## Town of Reading

Re: Sign Package & Photometric Plan - McDonald's 413 Main St, Reading, MA

**To:** Andrew MacNichol, Community Development Director  
**From:** Ryan A. Percival, P.E., Town Engineer;  
**CC:** Community Planning and Development Commission;  
**Date:** August 31, 2023  
**Re:** Proposed Site Re-development 413 Main Street - McDonald's

PLAN APPROVALS	SIGNATURE	DATE	BY
	APPROVED: MCDONALD'S AGENT		
STATUS	DATE	BY	
DRAWN BY:	04/28/2023	CSE	
PLAN CHECKED	-	-	
AS-BUILT			
SHEET NO.	<b>C-301</b>		OF 15

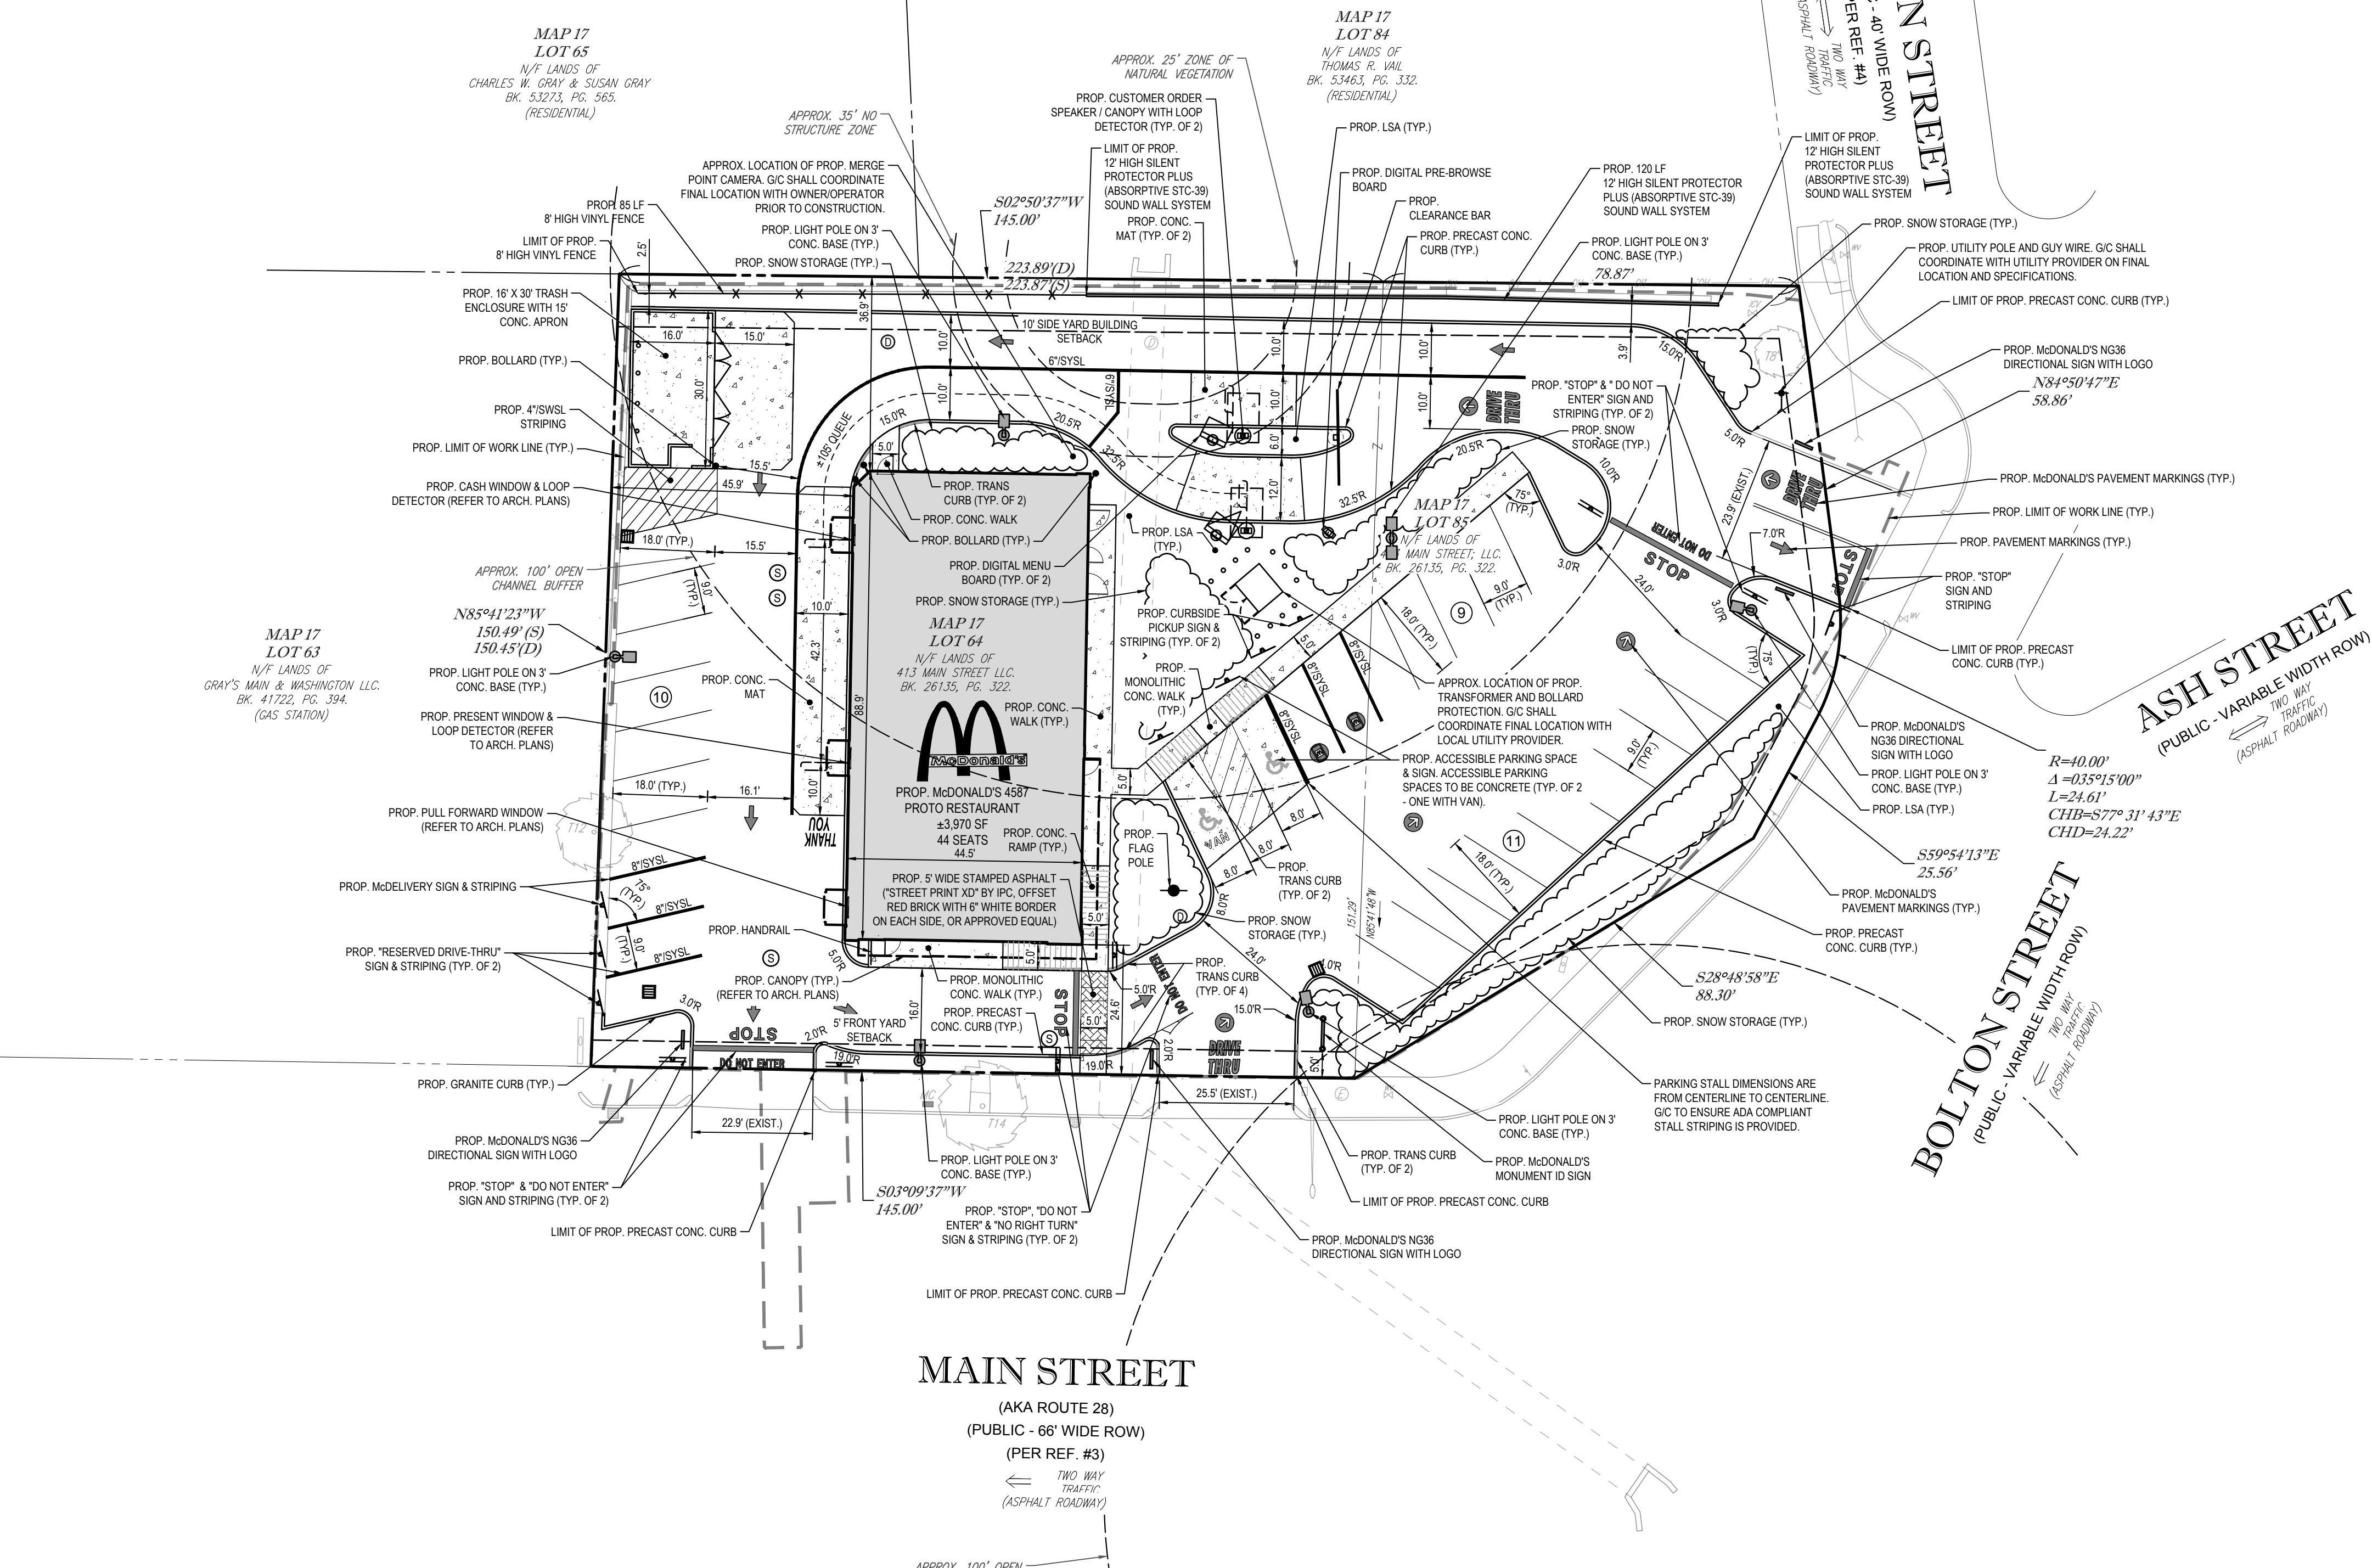
- Thought should be given to the placement of the crosswalk in front of the building to provide better protection to pedestrians. The stop bar is after the crosswalk allowing vehicles to stop on the crosswalk, the stop bar and/or crosswalk should be relocated.

**Response 3:** The crosswalk location has been proposed in order to provide an accessible connection from the public sidewalk as required by ADA/AAB regulations and also the furthest point away from vehicles making the turn into the recirculation lane. The plans have been revised to relocate the stop bar and signage before the pedestrian crosswalk and the crosswalk will be treated with red stamped asphalt in contrast to the asphalt surface for improved visibility. A "Pedestrian Warning" for vehicles is also now proposed prior to the crosswalk. Please refer to Sheet C-301 of the "Proposed Site Plan Documents".

STREET ADDRESS 413 MAIN STREET	
CITY READING	STATE MA
COUNTY MIDDLESEX	
SITE I.D. 20-0015	PLAN DESCRIPTION <b>UTILITY PLAN</b>

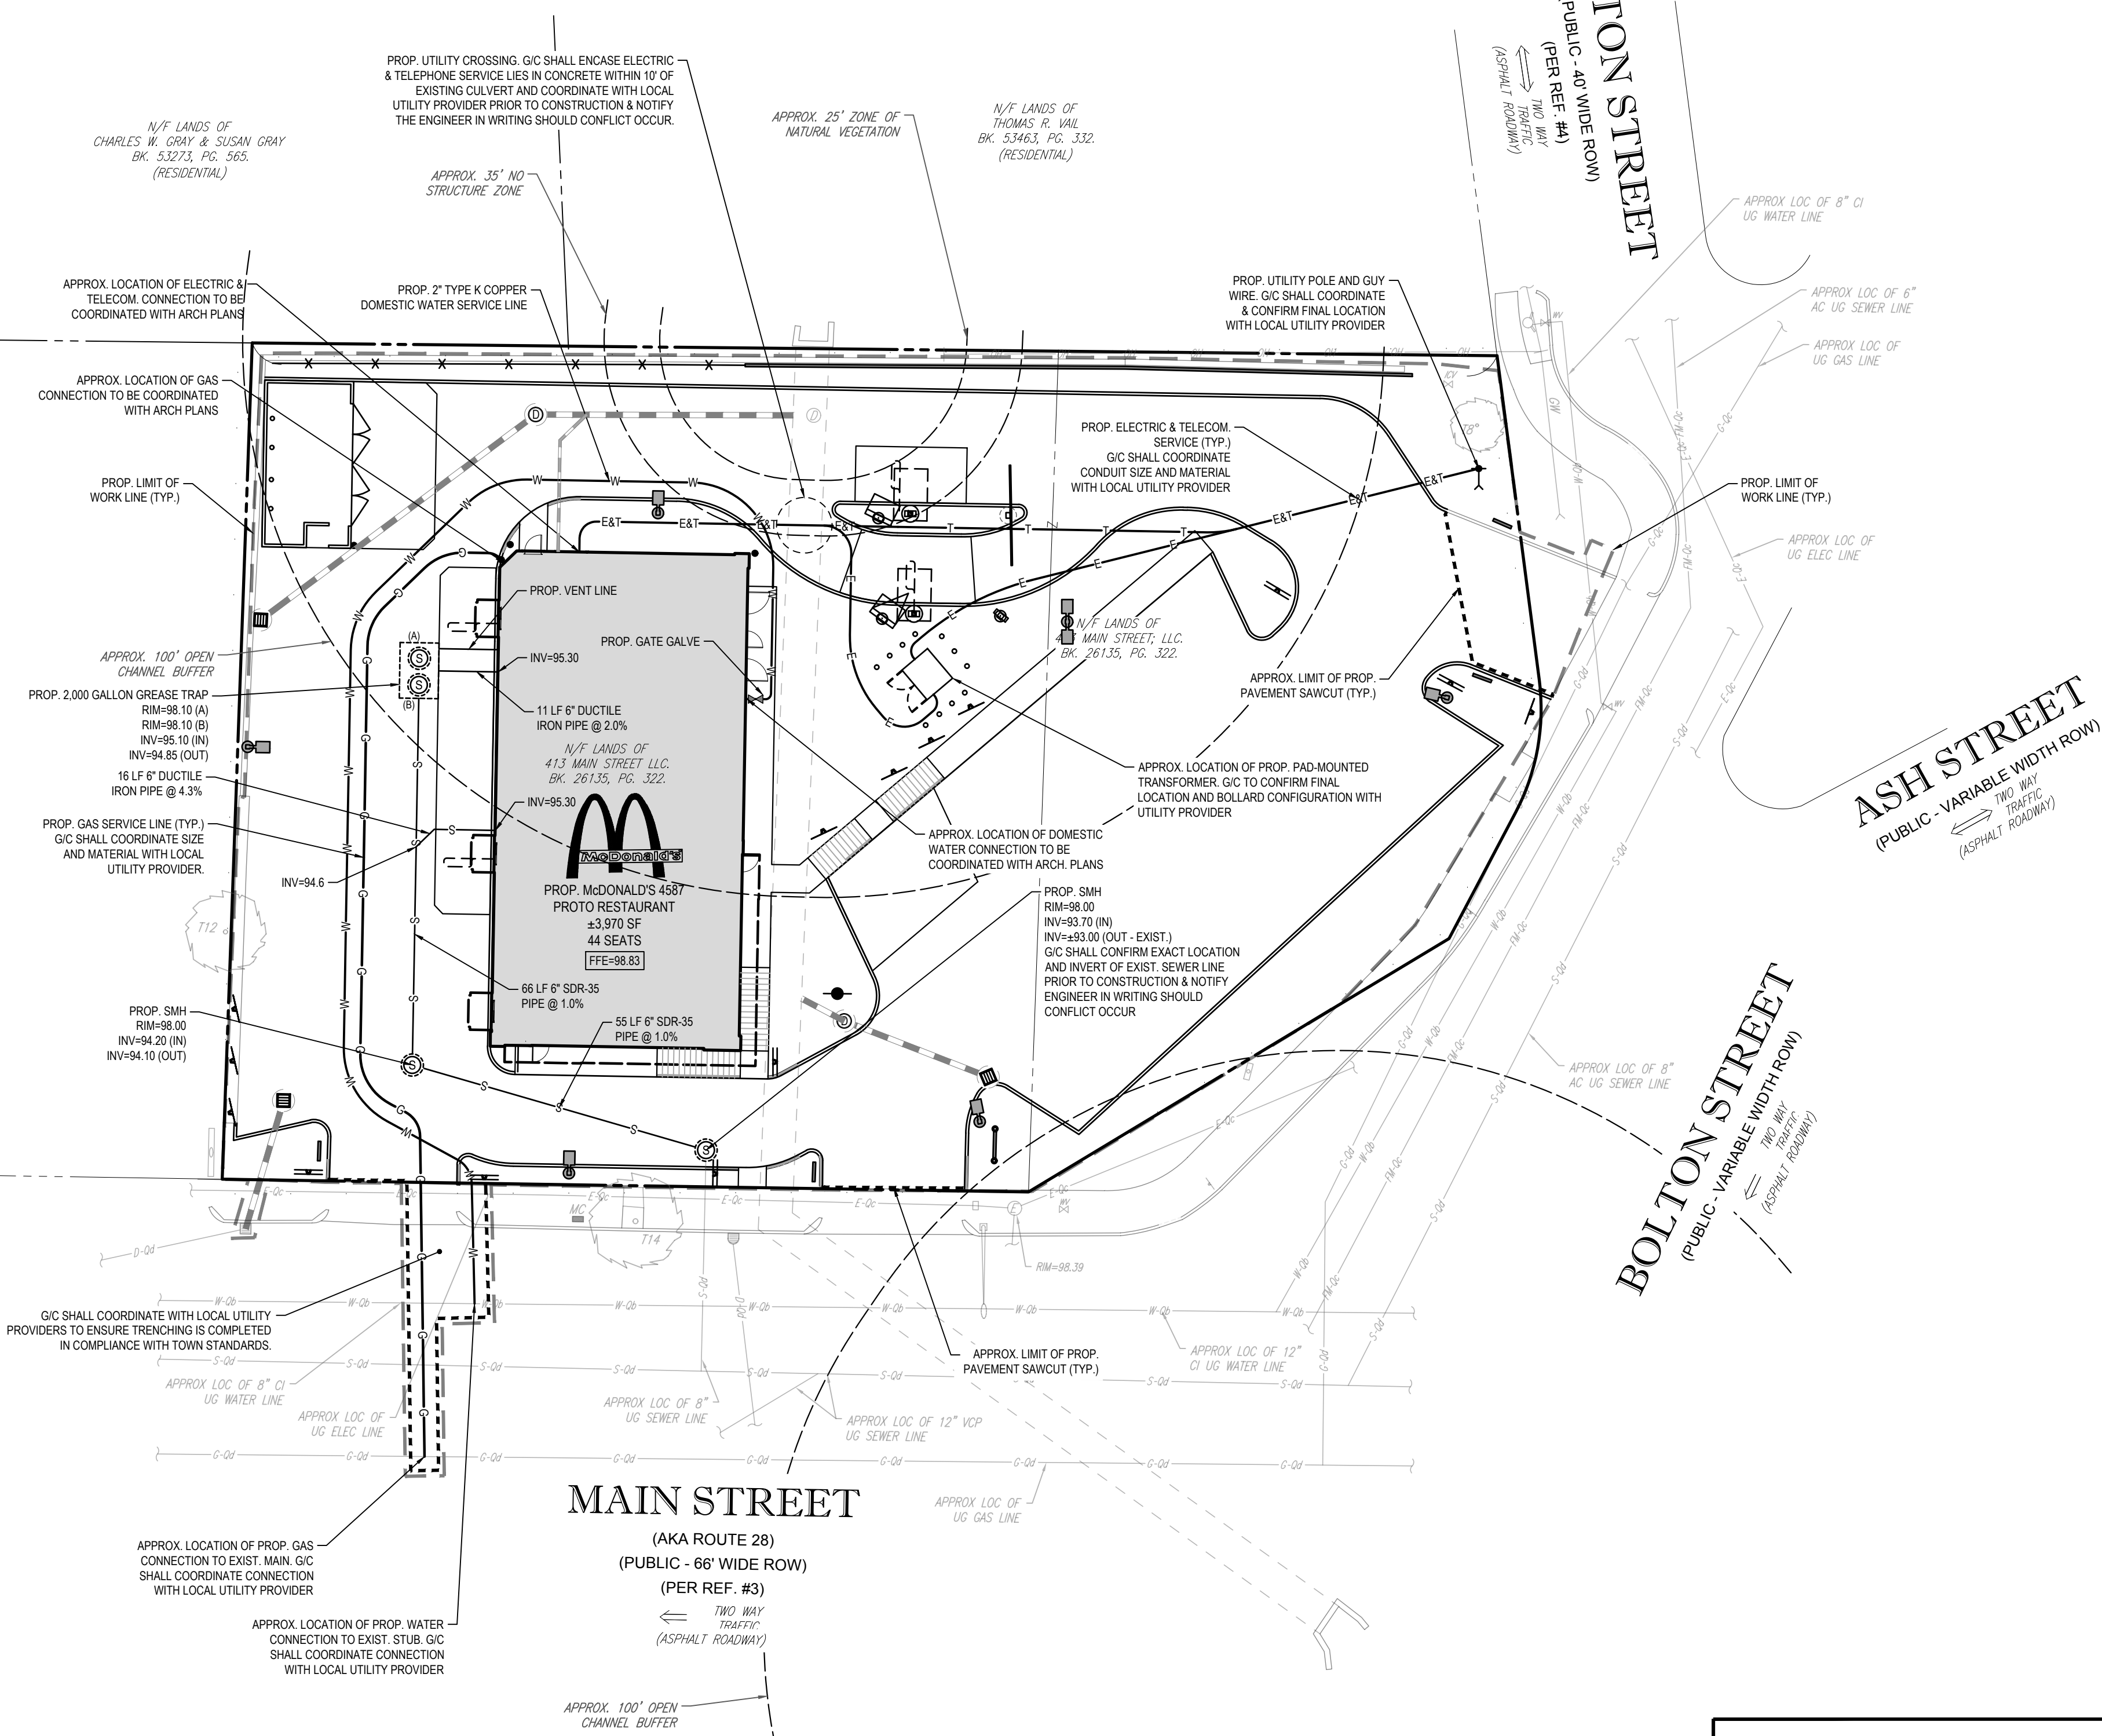
- The applicant shall CCTV inspect the Town's box culvert prior to construction.
- The size and type of all existing and proposed utilities shall be labeled on the plan.

**Response 8:** Size and type of all available existing utility information and proposed have been labeled on the plan. Please refer to Sheet C-401 and C-501 of the "Proposed Site Plan Documents" for additional information.
